Project	IEEE 802.16 Broadband Wireless Access Working Group < http://ieee802.org/16 >	
Title	Mobility Management with Multi-Carrier Support in IEEE 802.16m	
Date Submitted	2008-03-10	
Source(s)	Kelvin Chou, I-Kang Fu, Yih-Shen Chen and Paul Cheng MediaTek Inc. No.1, Dusing Rd. 1, HsinChu Science-Based Industrial Park, HsinChu, Taiwan 300, R.O.C.	Kelvin.Chou@mediatek.com Yihshen.Chen@mediatek.com IK.Fu@mediatek.com Paul.Cheng@mediatek.com
Re:	IEEE 802.16m-08/005, "Call for Contributions on Project 802.16m System Description Document (SDD)". In response to the following topics: <ul style="list-style-type: none"> • Comments on the content of Section 8 of IEEE 802.16m-08/003 	
Abstract	This contribution depicts how the mobility management, mainly handover process, can benefit from the support of multiple RF carriers. Similar idea can also be applied to other function blocks including radio resource management and MBS. Text proposal and figure updates to describe multi-carrier support block and its interactions with other function blocks are also proposed to be included in Section 8 of 802.16m SDD.

Mobility Management with Multi-Carrier Support in IEEE 802.16m

Figure 9x. The IEEE 802.16m MS/BS Data Plane Processing Flow

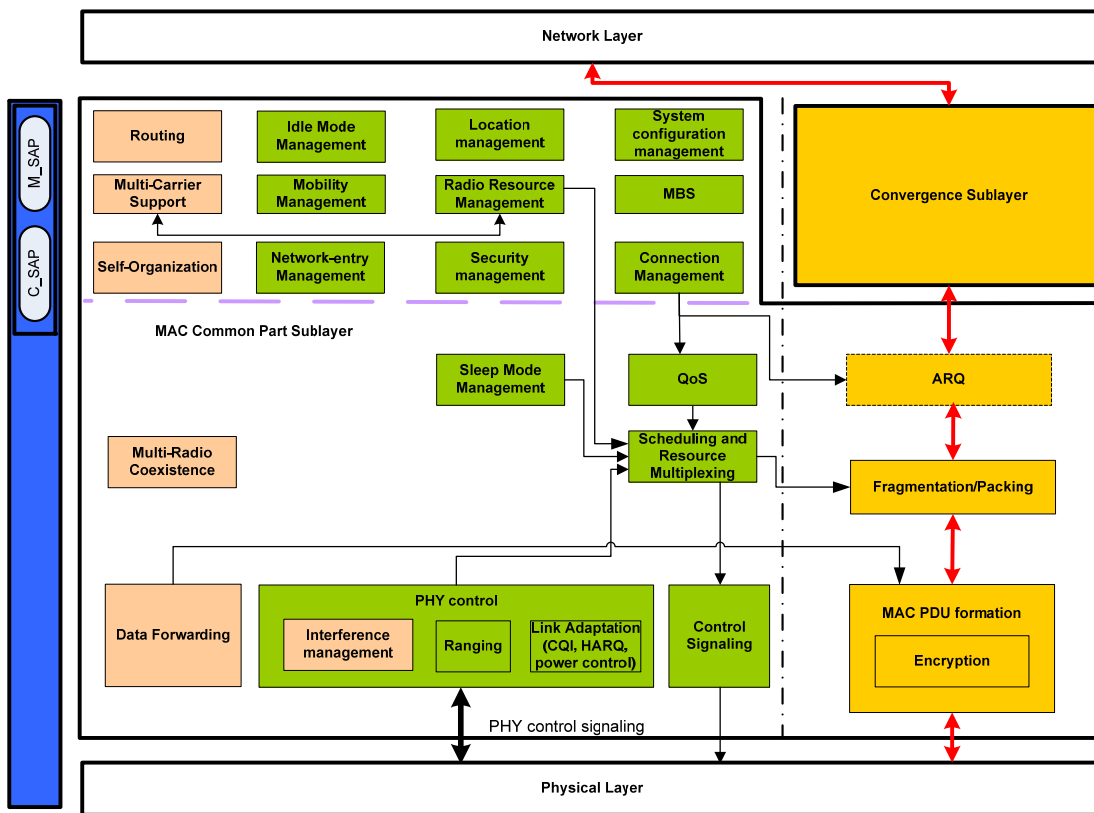
[In 80216m-08_003, Section 8.2.1, replace Figure 8 with Figure 9x below]

Figure 10x. The IEEE 802.16m MS/BS Control Plane Processing Flow

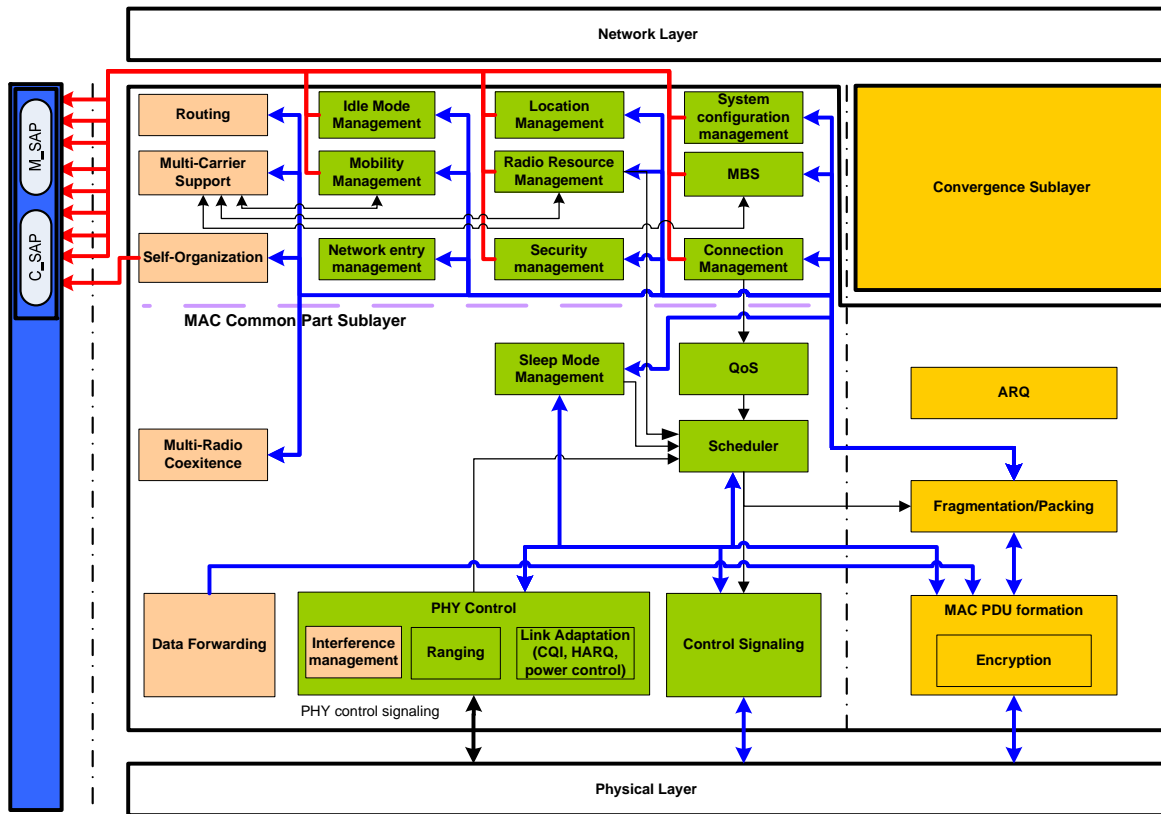
[In 80216m-08_003, Section 8.2.2, replace Figure 9 with Figure 10x below]
